DESIGN REVIEW BOARD REGULAR MEETING

Wednesday, February 11,
2026
6:00 p.m.

Subject: 26-01-DRB - 119 Union Avenue

Subject: 26-02-DRB - 330 Avenue D

C.3 Storefronts

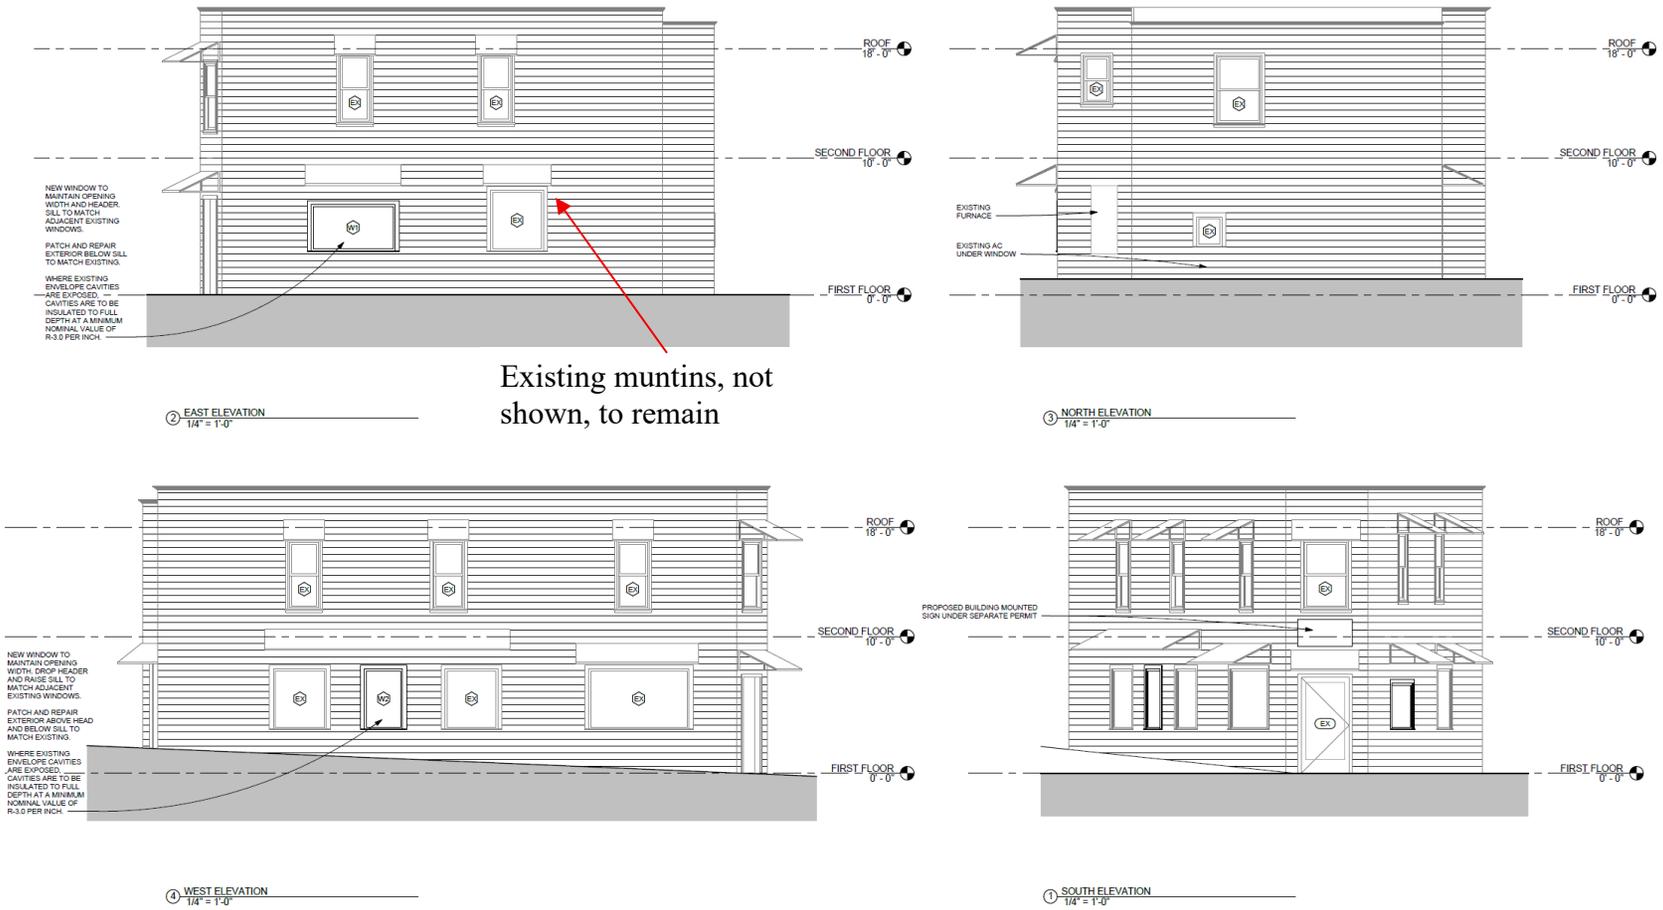
The subject building does not appear to have a traditional storefront. No changes are proposed that would affect storefront features, apart from converting side-facing doors to windows.

Under previous approval #06-02-DRB,
the double doors were installed:

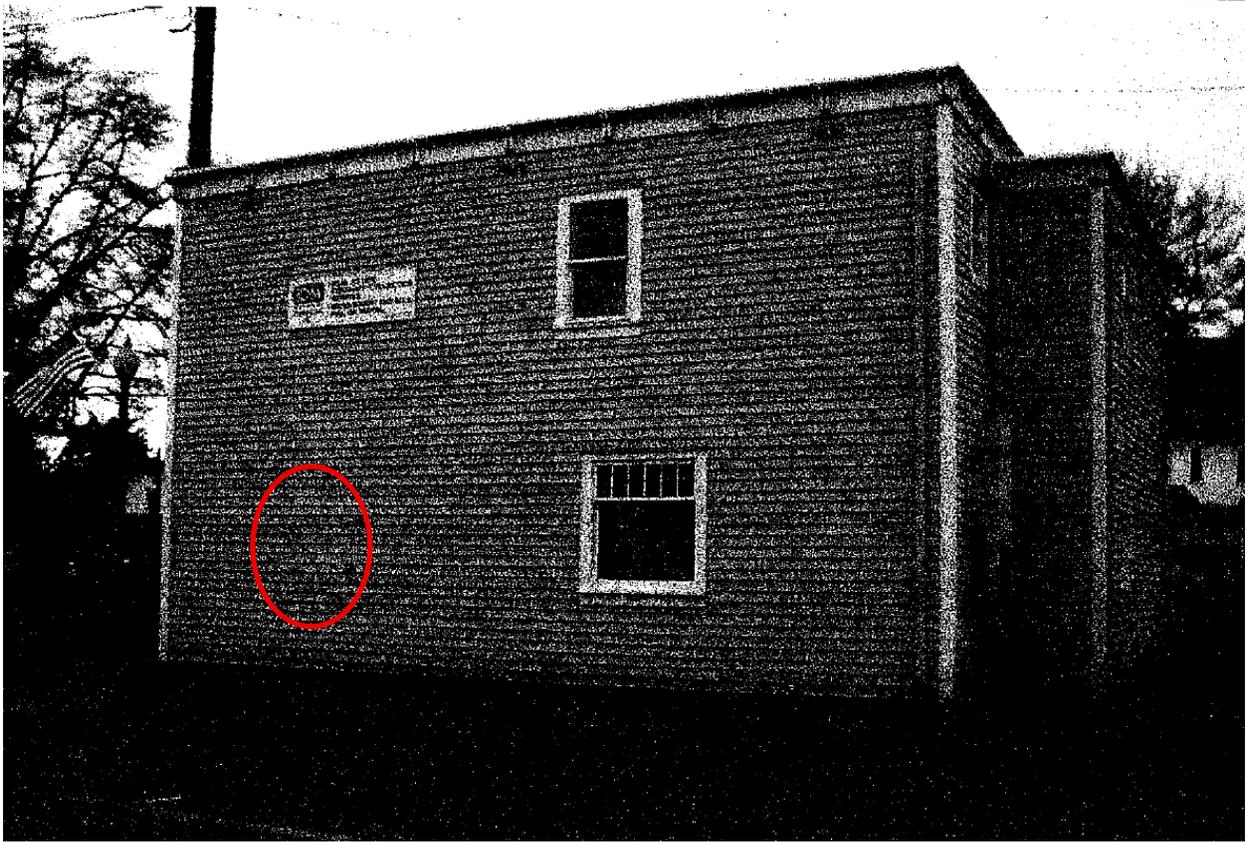
The double doors on the east facade were added to a previously blank wall in 2006 under DRB File #06-02-DRB. A historic photo of this facade prior to the approved modification is provided in the attachment. The current proposal will remove the doors and replace them with fixed windows, retaining the opening widths and the sill heights are proposed to match the adjacent windows. The header of the proposed window on the west facade will align with the adjacent windows while the existing header on the east facade will be retained as the sills will align. It is unknown whether the door on the west facade is original or was added later.

Proposed work area:

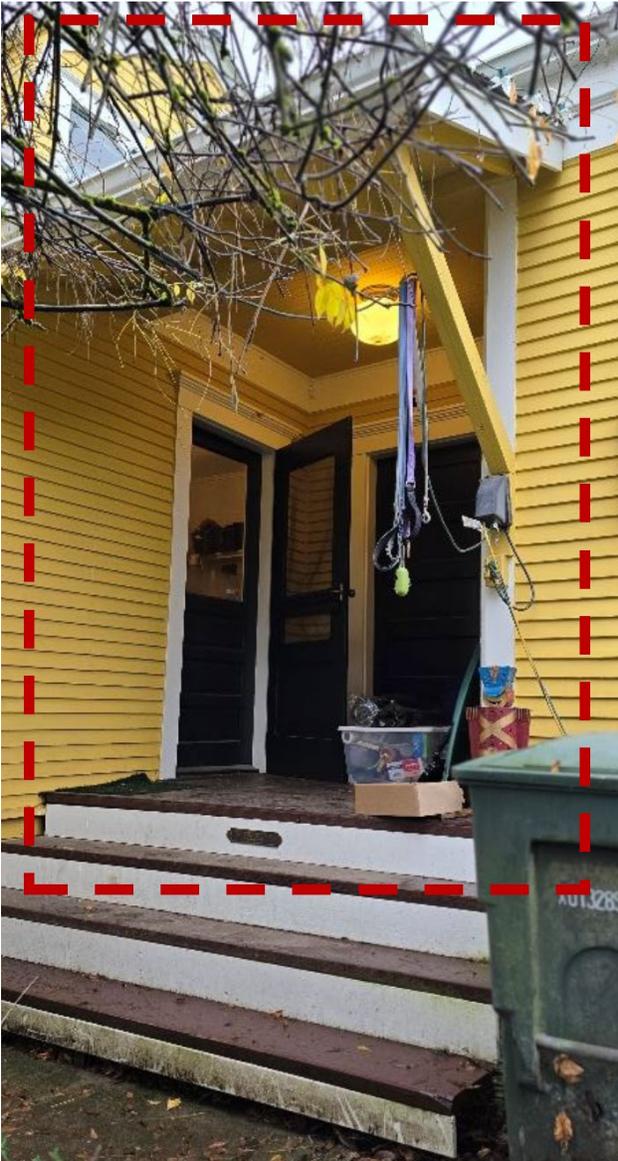
STAFF ANALYSIS: The applicant is proposing to enclose the existing covered secondary entry facing Fourth Street located on the north façade. The proposal will convert the space into a foyer. The applicant is also proposing to enlarge the picture window on the south façade facing the yard, retaining its original location, design, and proportions.

Both project areas are located toward the rear of the home with limited views from the street. The covered entry enclosure is shielded from street view by a large conifer tree.

PROPOSED MAIN FLOOR PLAN- 42 SQ. FT. (ADDITION)

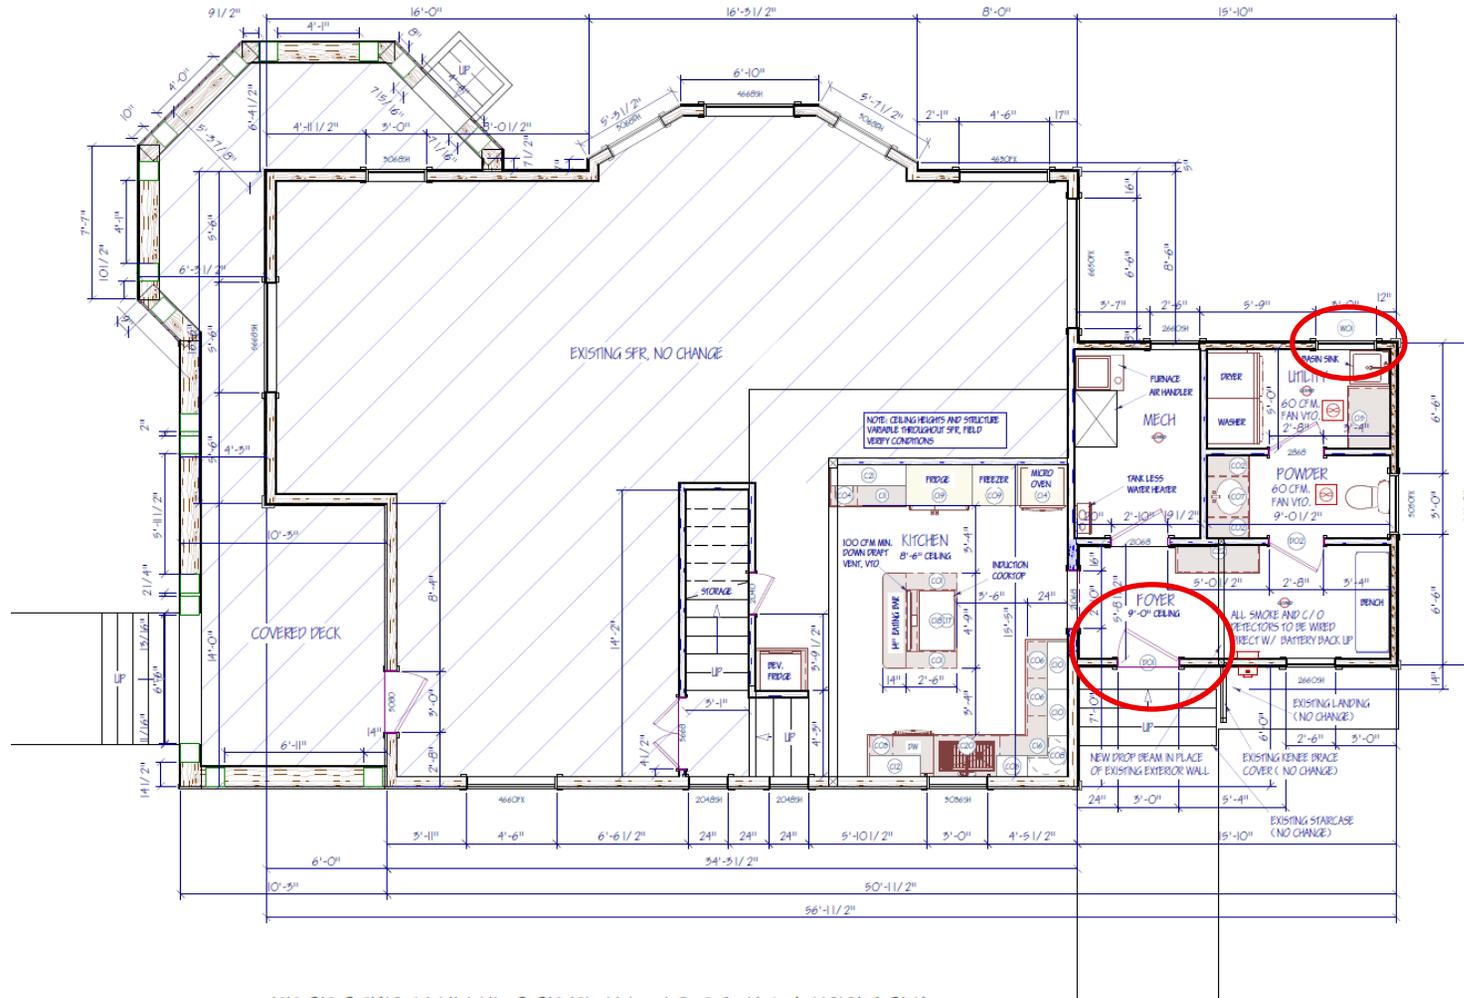
The structure is a two-story Queen Anne style home constructed in 1917. The proposal includes reusing one of the three existing exterior doors, including all components of the existing trim system. Lap siding will also be reused to the degree possible or replaced in kind.

<p>C.1 General</p> <ol style="list-style-type: none"> a. Architectural styles and stylistic references shall be consistent throughout one building. b. Architectural features should not be removed or changed if original to the building. c. Unpainted masonry shall not be painted. 	<p><i>A consistent architectural style will be retained throughout the building with the reuse of the door, trim, and siding.</i></p>
<p>C.2 Building Materials</p> <p>Exterior surface materials shall be consistent with traditional architectural materials and shall contribute to the appearance of a 100-year functional building life. Appropriate materials include brick, stone, wood, stucco, cast iron, and metal panels, when reflective of historic industrial buildings. The following exterior surface materials are prohibited:</p> <ol style="list-style-type: none"> a. Plain or smooth face concrete masonry unit b. Corrugated metal c. Imitation or synthetic cladding materials such as vinyl, plastic, or aluminum d. T1-11 siding e. Perforated pressure treated wood, when readily visible f. Plexiglass 	<p><i>No prohibited materials appear to be proposed. All proposed materials will be either reused or will match existing.</i></p>

SOUTH ELEVATION

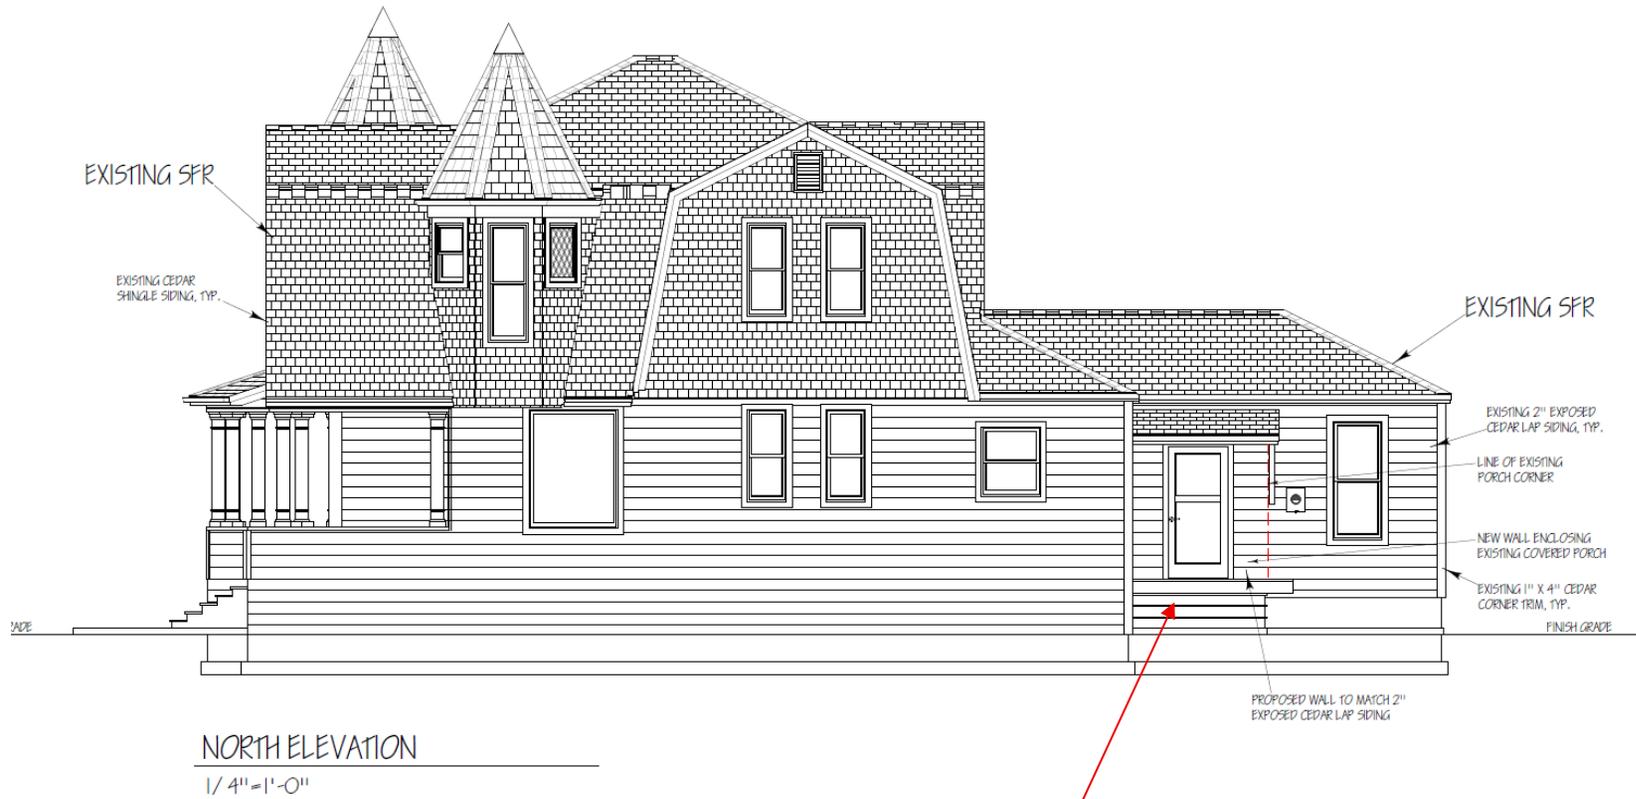
<p>C.4 Windows</p> <ol style="list-style-type: none"> a. When present and intact, existing windows shall be maintained and preserved in their original size, location, design, and proportions. b. New and replacement windows shall appear to be set back from the exterior building plane and finished with trim elements that are appropriate for the building. The use of vinyl windows is discouraged. c. New window openings shall not be added on the primary façade. d. Filling in or altering the size of historic window openings on the primary façade is not appropriate. 	<p><i>The proposed window enlargement is not visible from the street and faces inward toward the private yard. The Board should consider whether the proposal meets the intent of the standard.</i></p>
